**From:** Burton, Michael <mburton@blm.gov>  
**Sent:** Monday, September 23, 2013 8:58 AM  
**To:** Lara Weinheimer  
**Cc:** Bratcher, Mike, EMNRD; Brian Wall  
**Subject:** Re: Linn H.E. West B #85 (2RP-1865) Corrective Action Plan

**LINN H.E. WEST**  
**B #85**  
**(2RP-1865)**

LEGALS: UL/K SEC. 03  
 T17S - R31E  
 EDDY COUNTY, NM

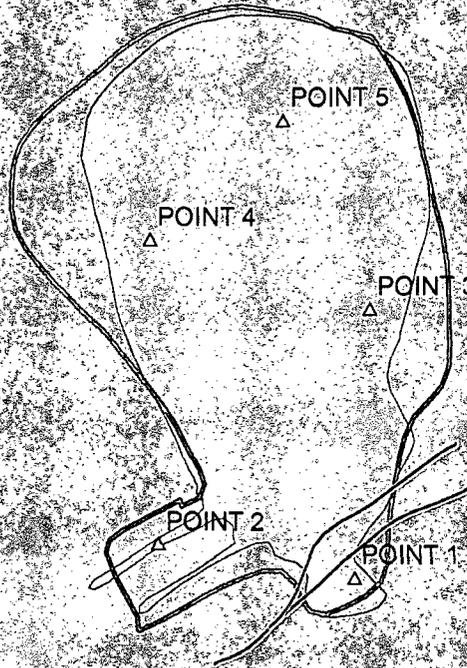
Gentlemen, attached is the lab data for the 5pt. bottom composite from the Linn West B #85. We are looking for approval to begin blending and contouring soil left on site after excavation as per BLM's recommendation. We would like to begin this process on Wednesday 11/7/13. Thanks

OCD approves commencement of the proposed procedure, pending like approval by BLM.
